August 8, 2025
ES-9607.02

**Subject: Response to Building Permit Review Comments
Cheshire Property
7615 East Mercer Way
Mercer Island, Washington**

City File No. 2503-130

LIQUEFACTION ANALYSIS

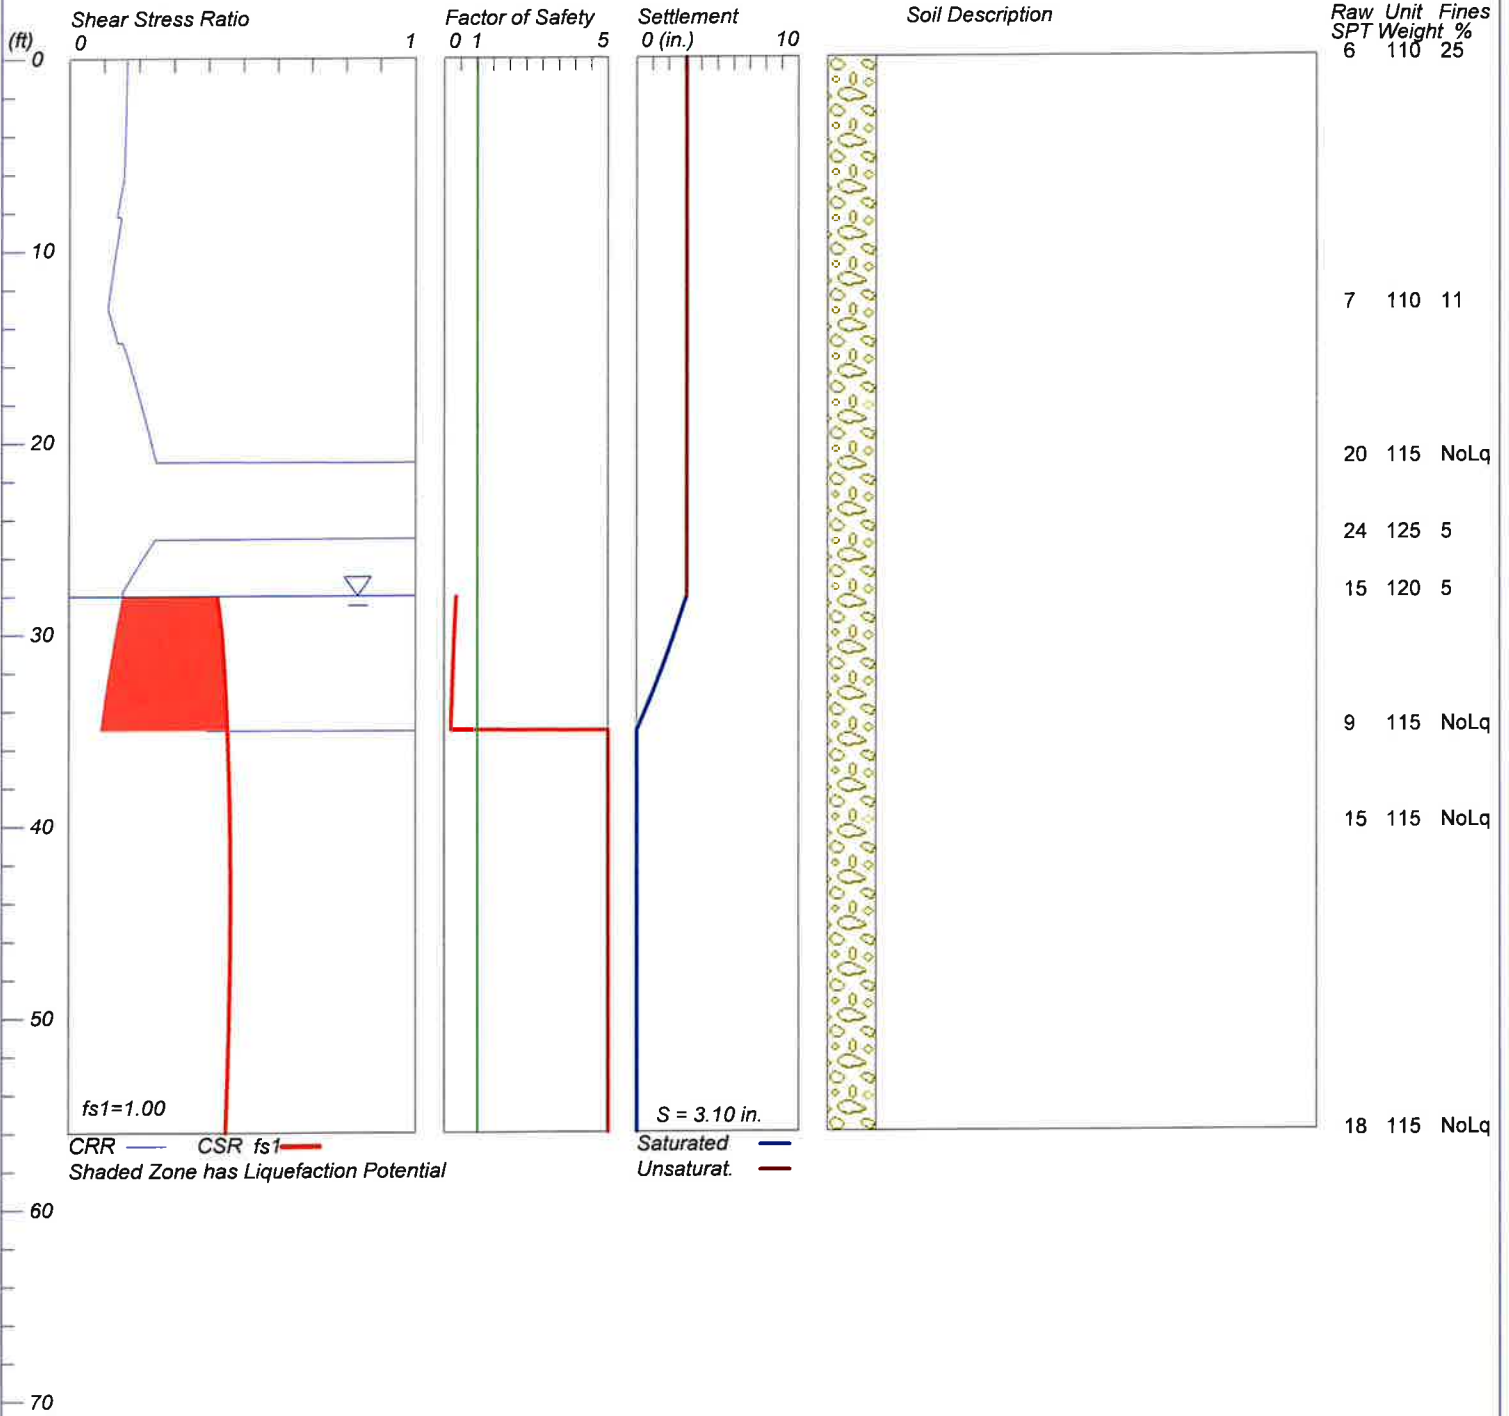
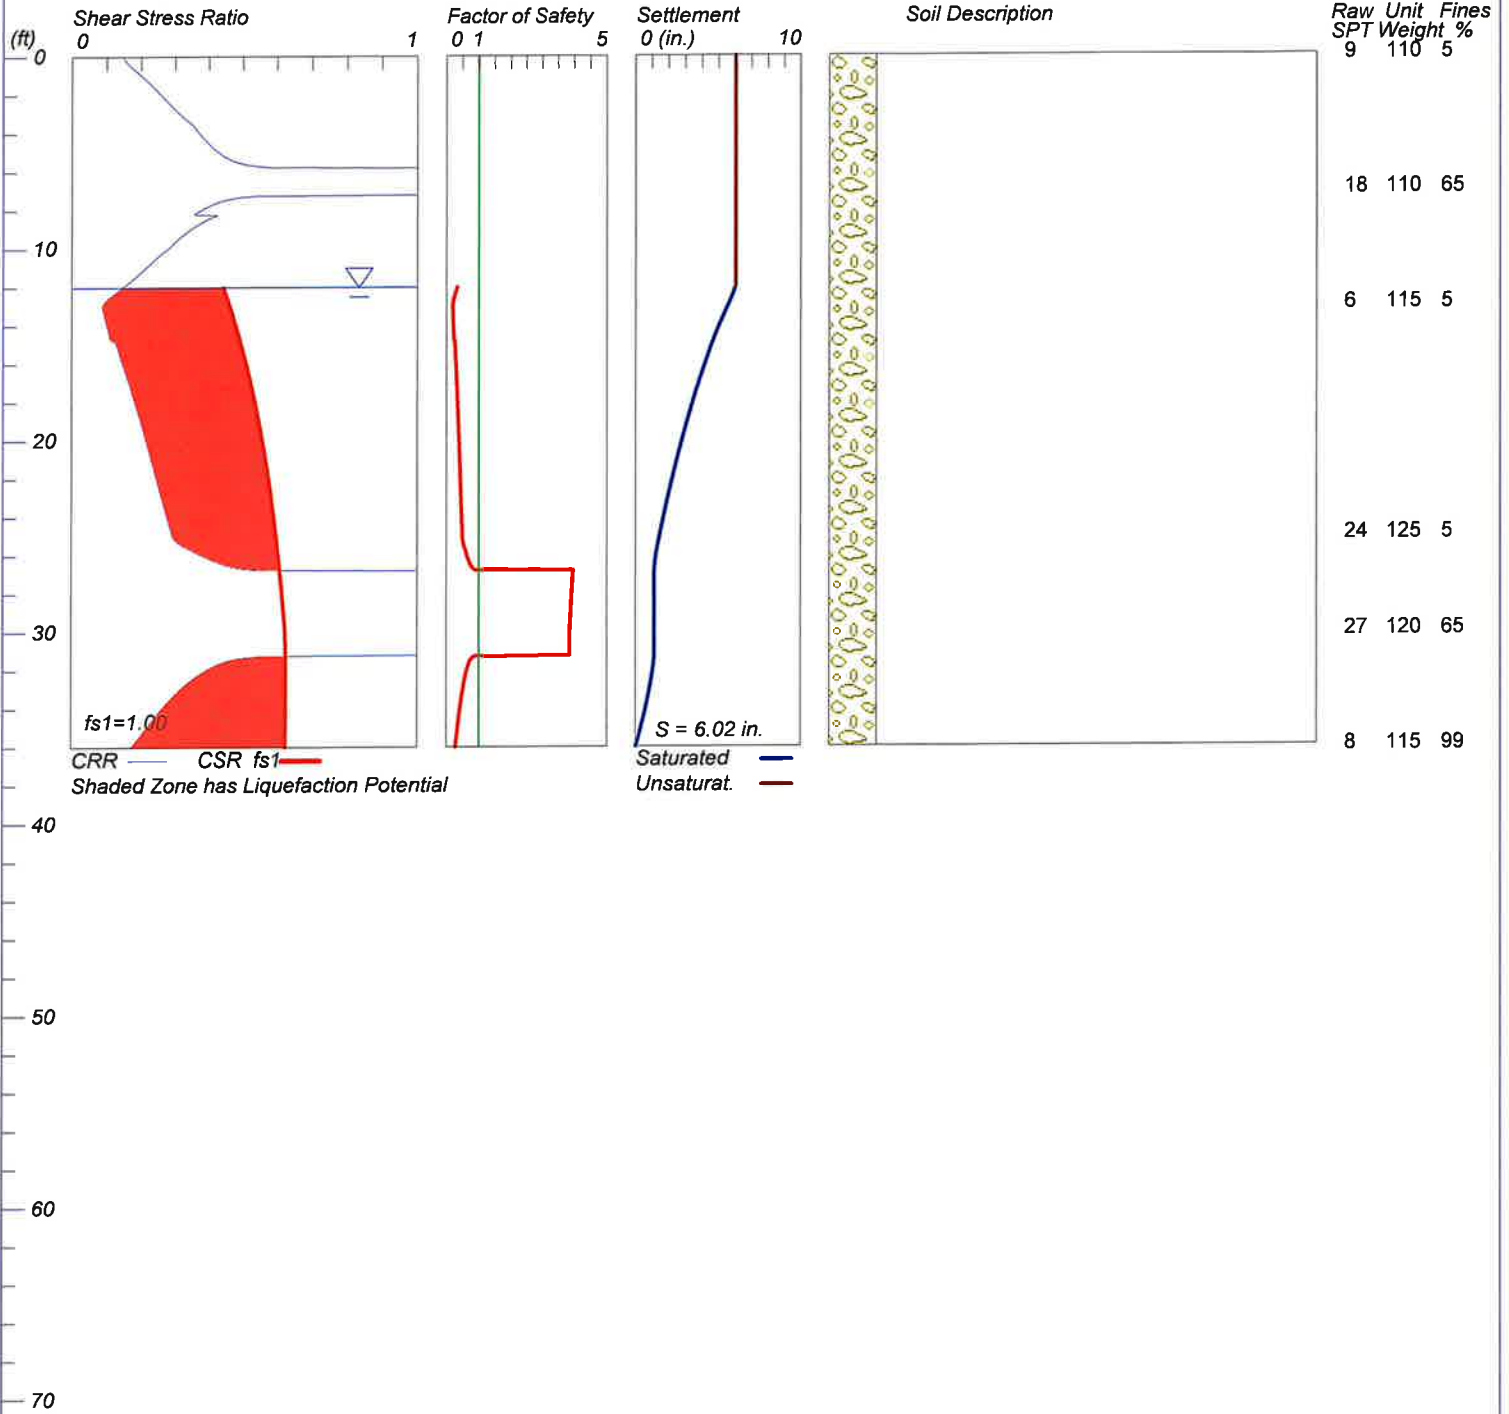
Please have the geotechnical engineer of record assess the potential for liquefaction at the site and estimate post-liquefaction settlement, lateral spreading or flow failures as required by IBC using a peak ground acceleration associated with a 2% probability of exceedance in 50 years earthquake. Please include liquefaction assessment calculations, any post-liquefaction settlement calculations, residual strength determinations and associated stability analyses and/or lateral deformation calculations for review.

Liquefaction modeling results are attached. The results of slope stability analyses and soil conditions described in the boring logs suggest that lateral spread is a highly unlikely probability of occurrence. The updated foundation support system will further protect the structure from collapse.
